ROLLIN RIDGE ESTATES

SITE GRADING & EROSION CONTROL PLAN

PRELIMINARY EPC PROJECT NO. SP-18-001

NORTHEAST SITE GRADING PLAN

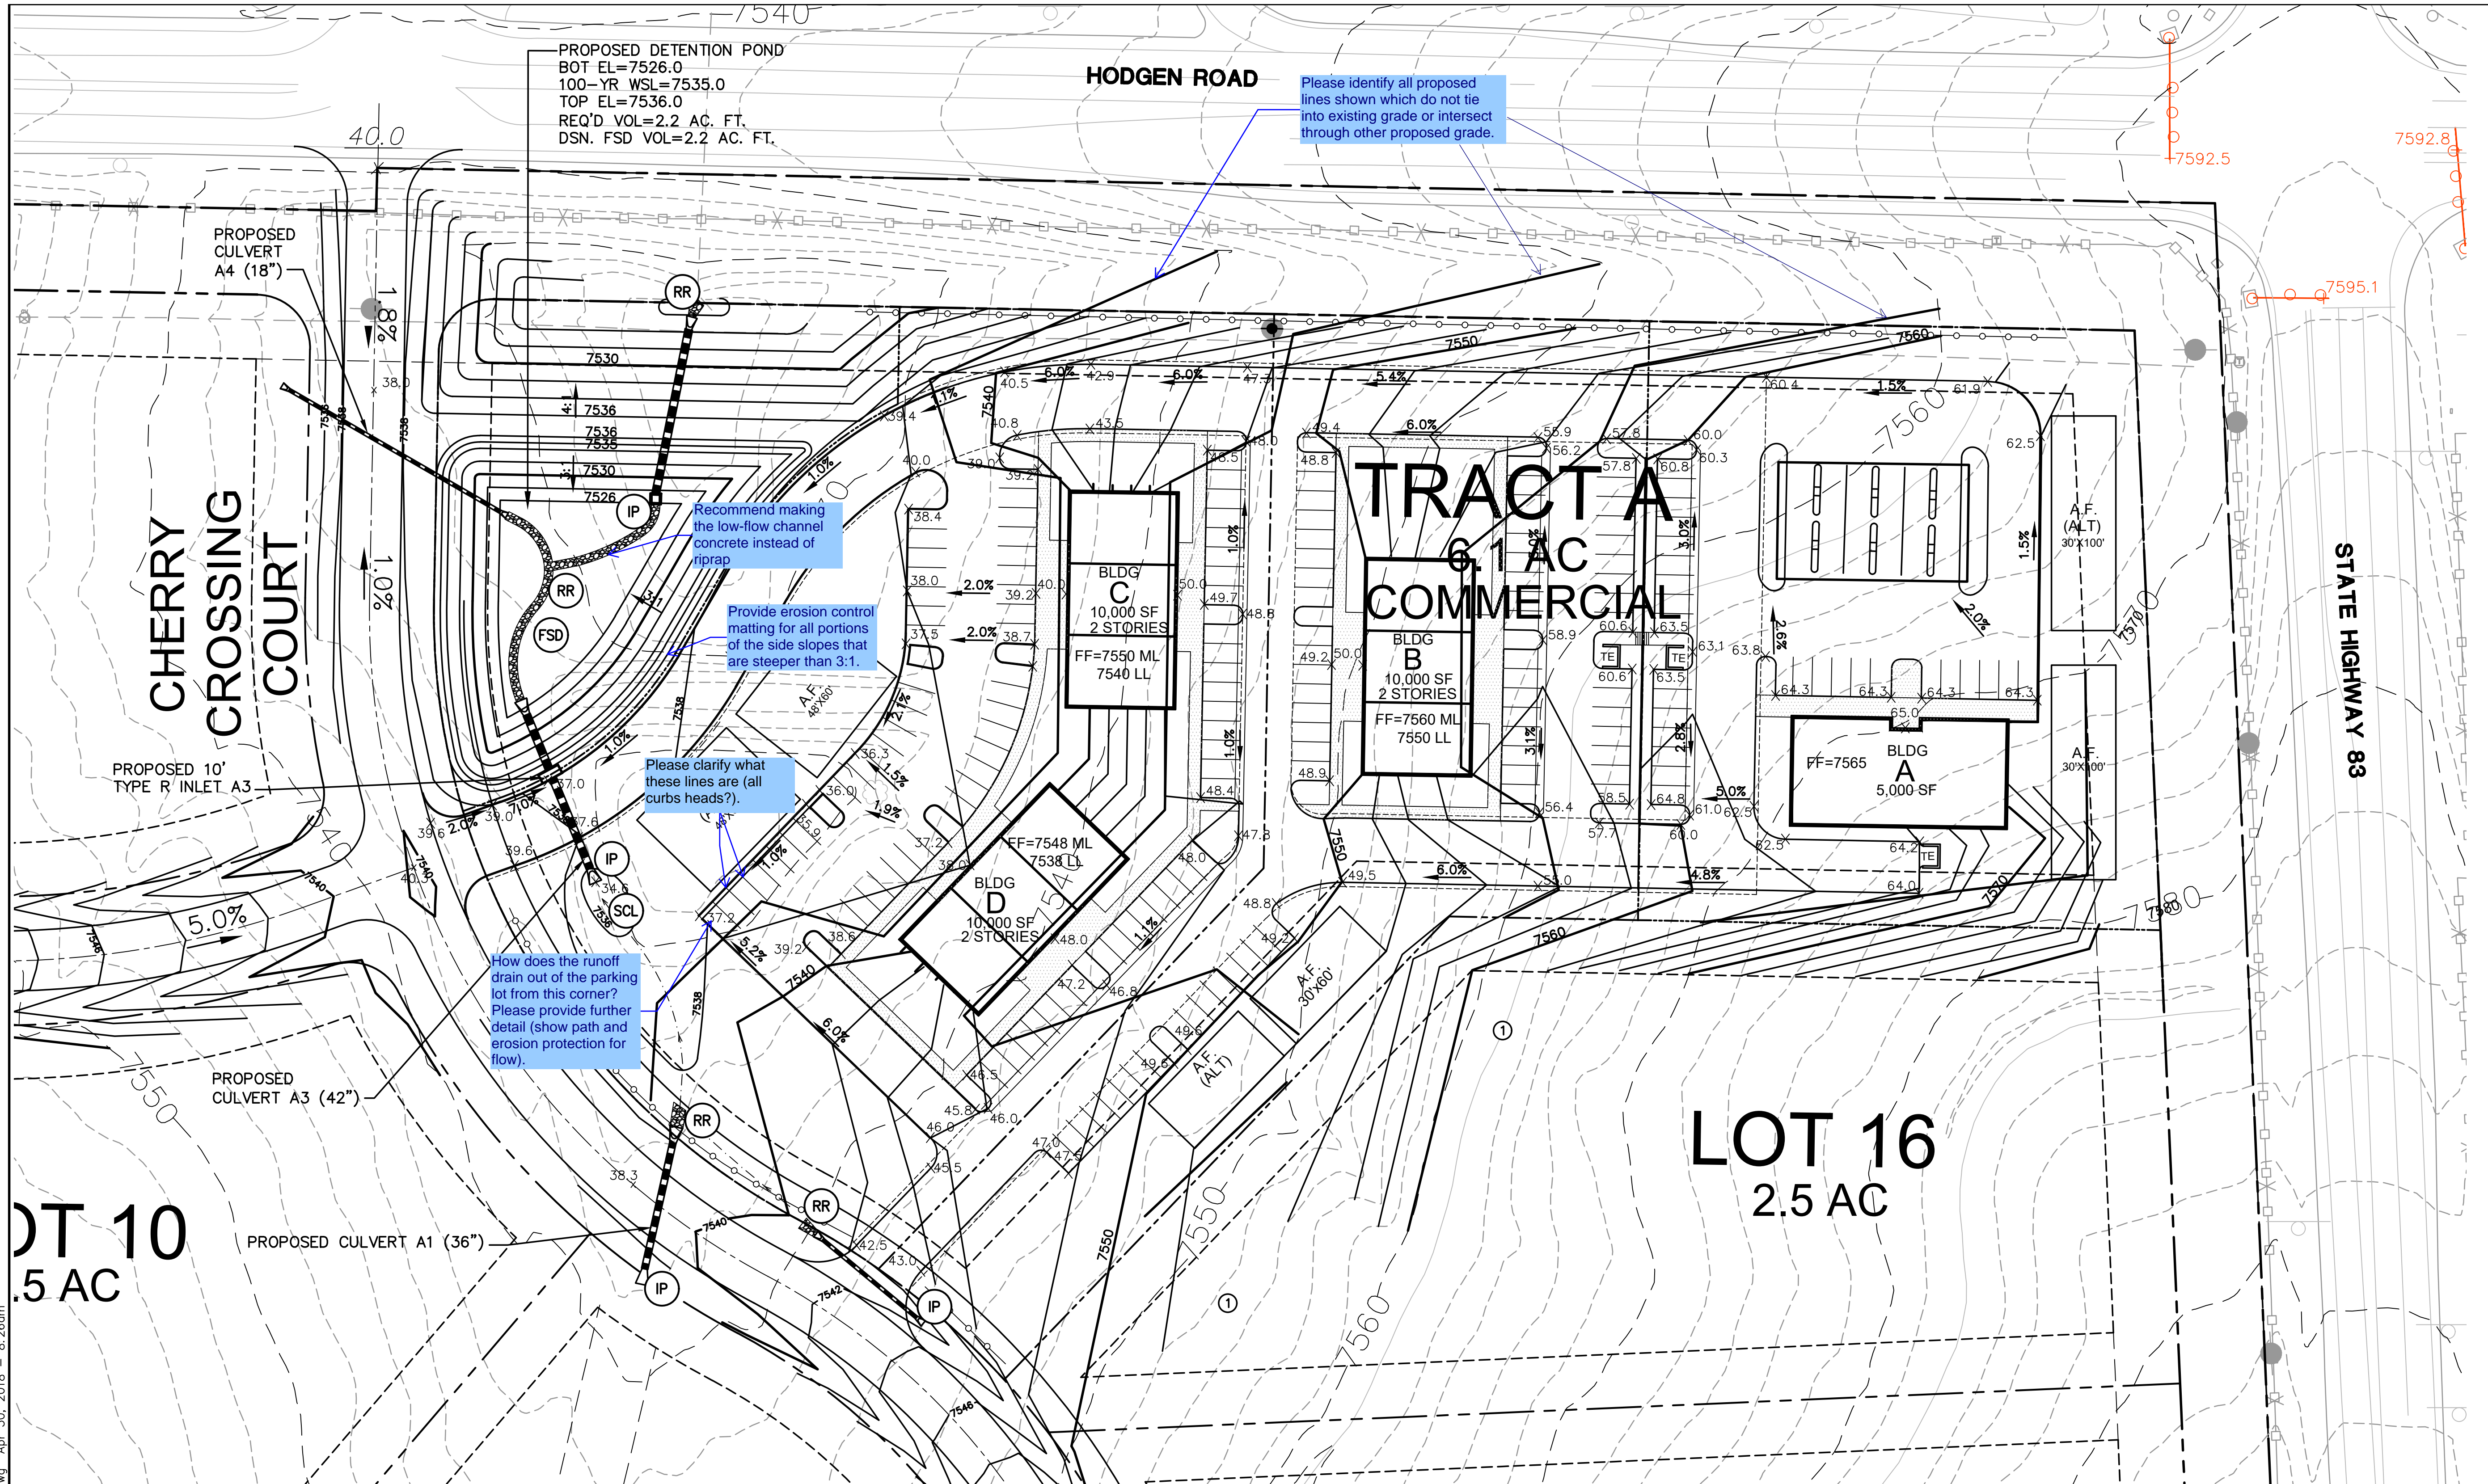
Please identify all proposed lines shown which do not tie into existing grade or intersect through other proposed grade.

Identify if the existing road will be removed

Update to the new road name

Please be sure to provide a construction BMP around the stockpile in the final GEC Plan

Temporary sedimentation basins are required. Please provide as necessary.
